STATE OF CALIFORNIA - DEPARTMENT OF TRANSPORTATION

CONTRACT CHANGE ORDER

CCO 1	Suppl. No. 0	Contract No. 04 - 0120S4	Road SF-80-12.7/13.2	FED. AID LOC.: NO FED AID

TYPICAL FOR DUCTBANK AND MANHOLES

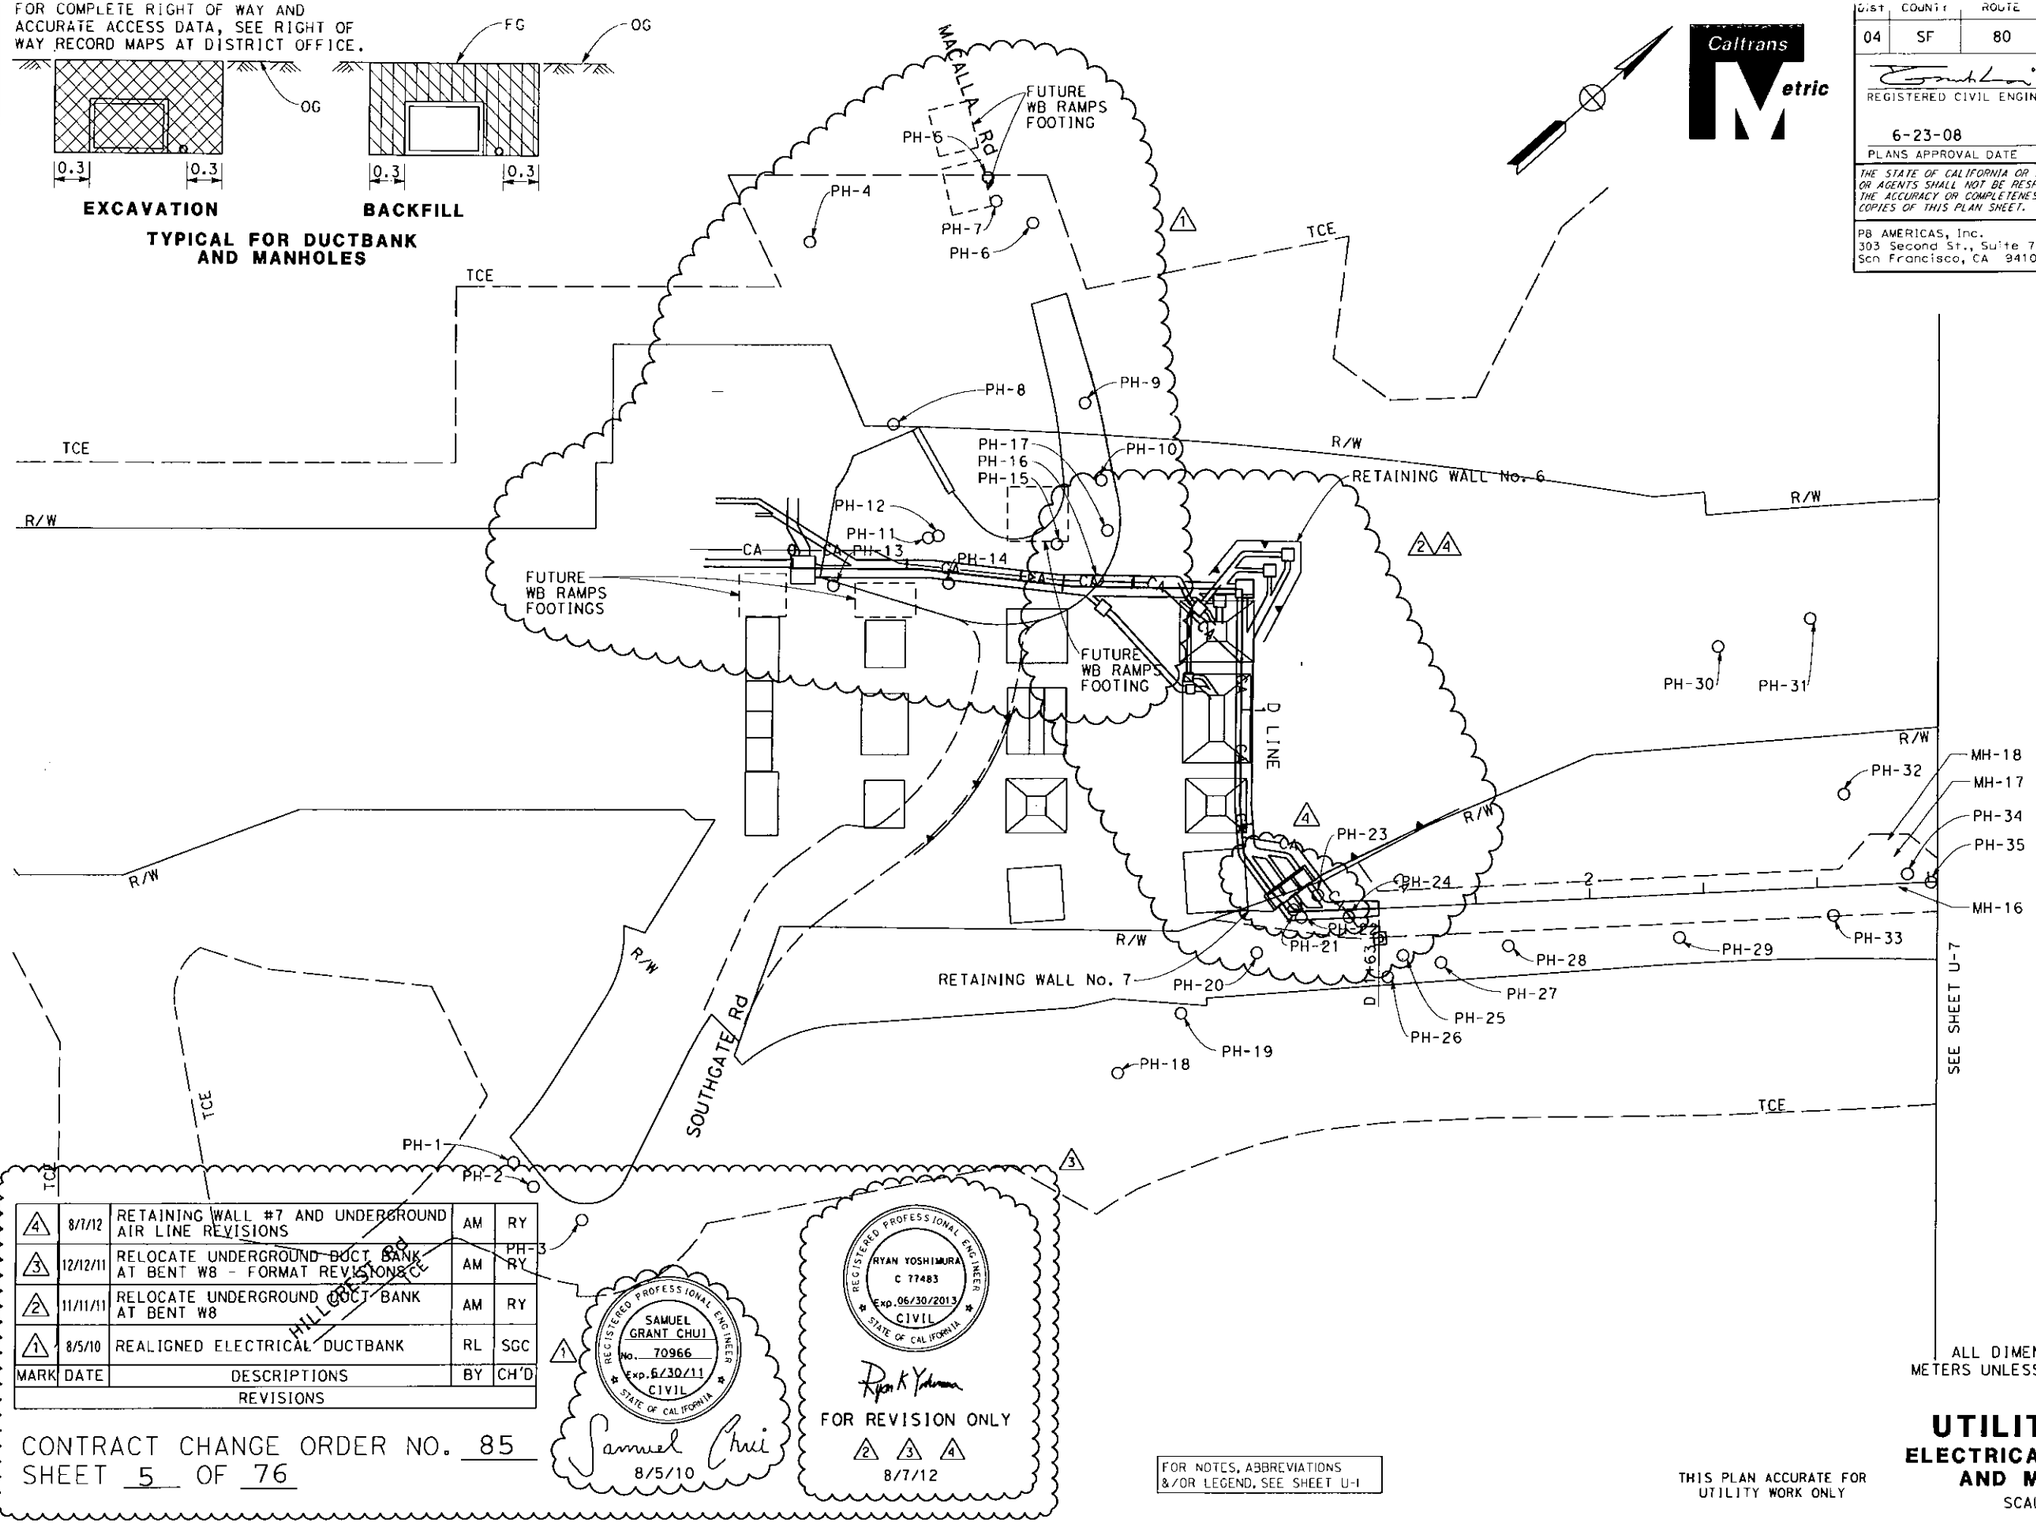
MARK	DATE	DESCRIPTIONS	BY	CH'D
4	8/7/12	RETAINING WALL #7 AND UNDERGROUND AIR LINE REVISIONS	AM	RY
3	12/12/11	RELOCATE UNDERGROUND DUCT BANK AT BENT W8 - FORMAT REVISIONS	AM	RY
2	11/11/11	RELOCATE UNDERGROUND DUCT BANK AT BENT W8	AM	RY
1	8/5/10	REALIGNED ELECTRICAL DUCTBANK	RL	SGC

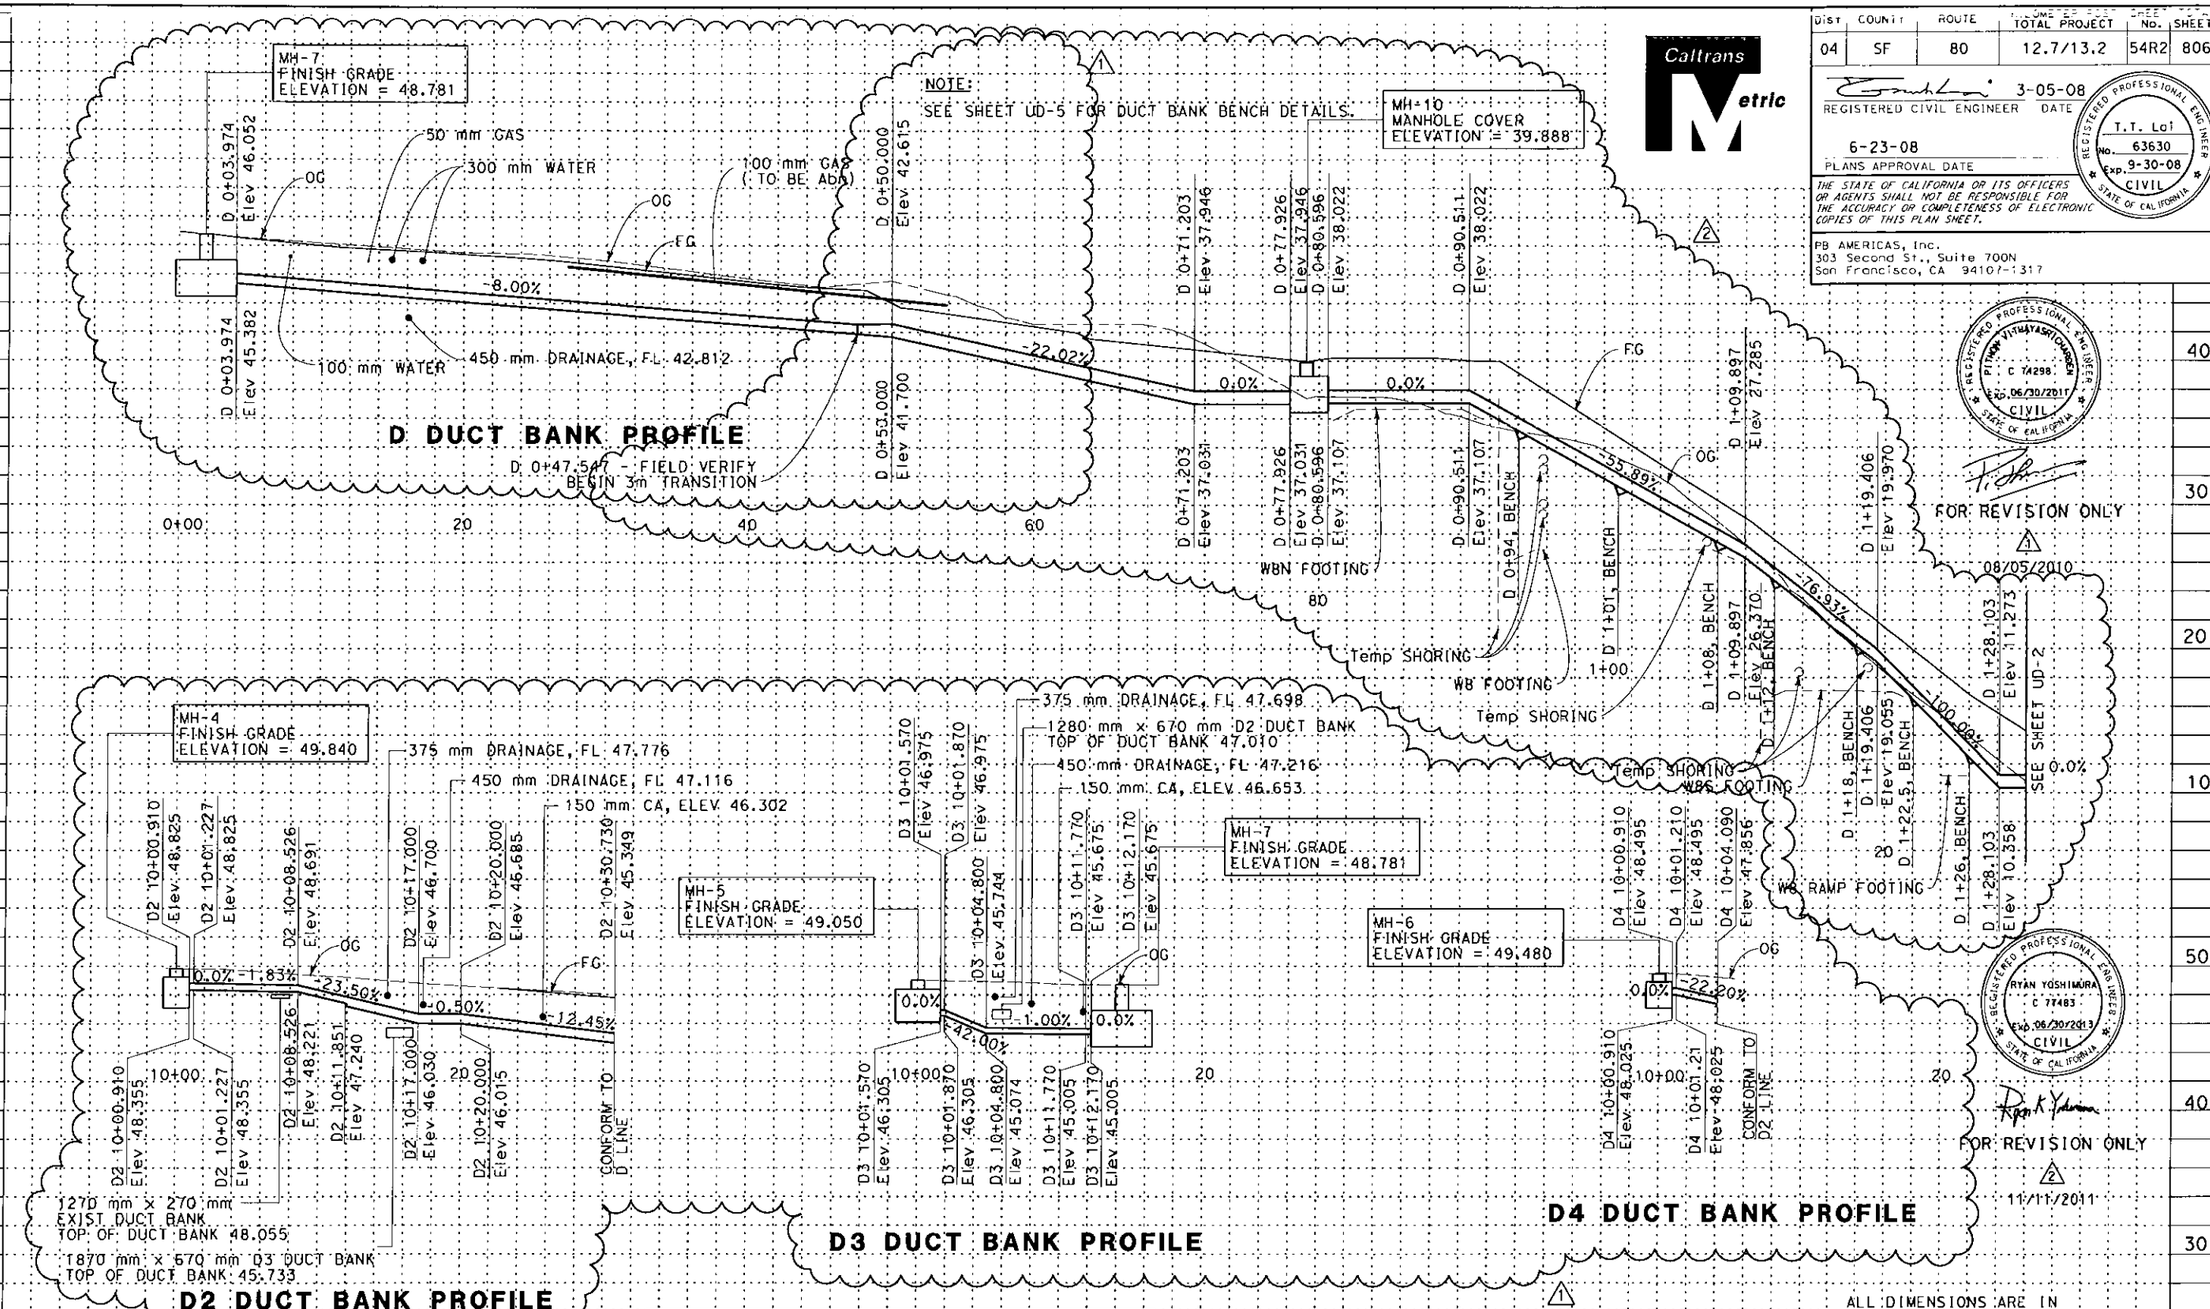
MARK	DATE	DESCRIPTIONS	REV	CK	DET
2	11/11/11	RELOCATE UNDERGROUND DUCT BANK AT BENT W8.	AM	RY	
1	6/11/10	REALIGNED ELECTRICAL DUCT BANK

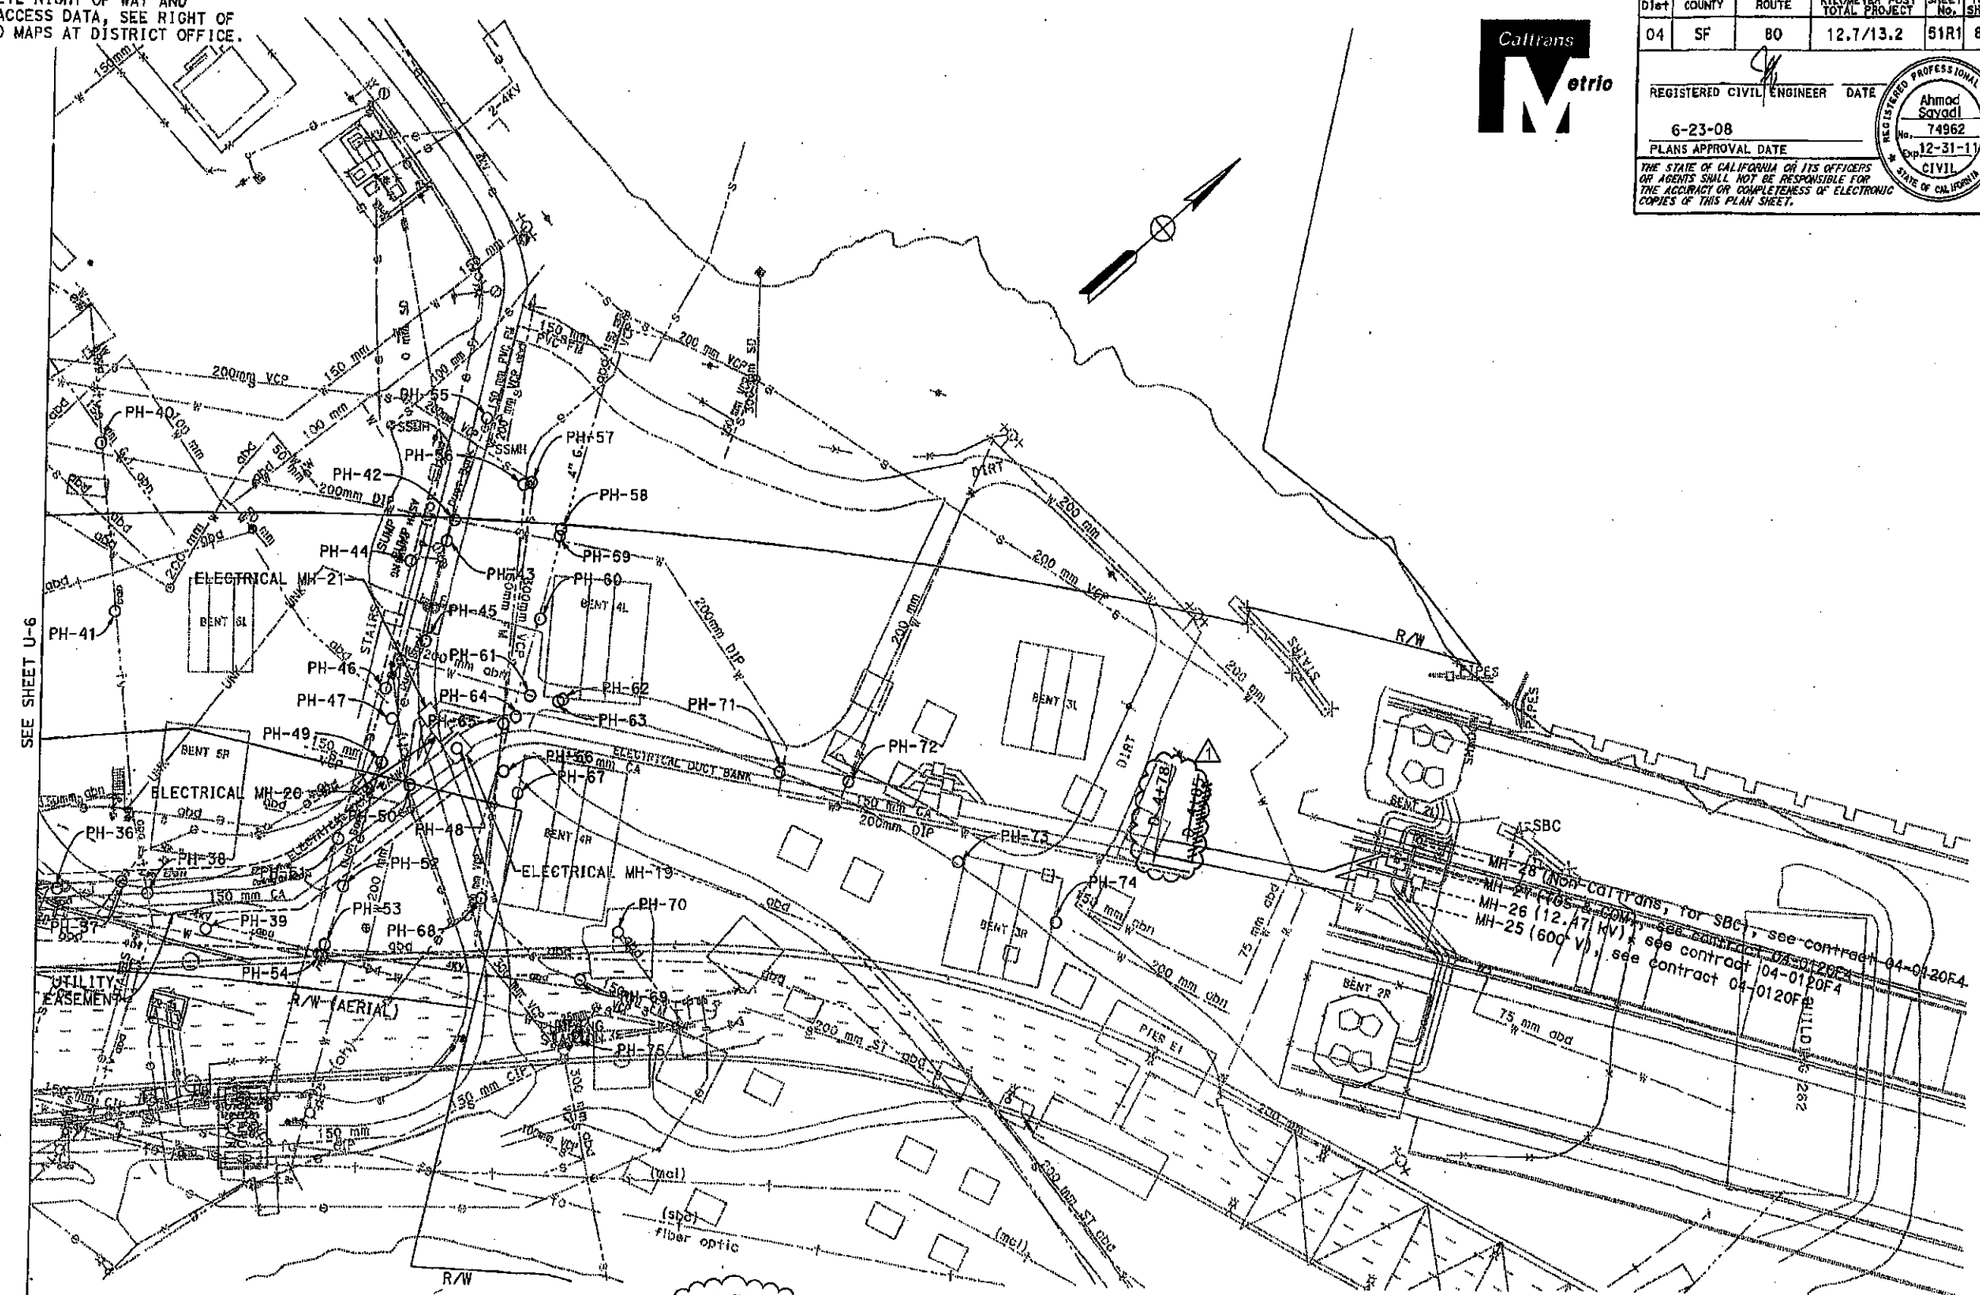
MARK	DATE	DESCRIPTIONS	BY	CH'D
1	10/25/10	REALIGMENT OF DUCT BANK, WATER LINE AND COMPRESED AIR	RL	SGC
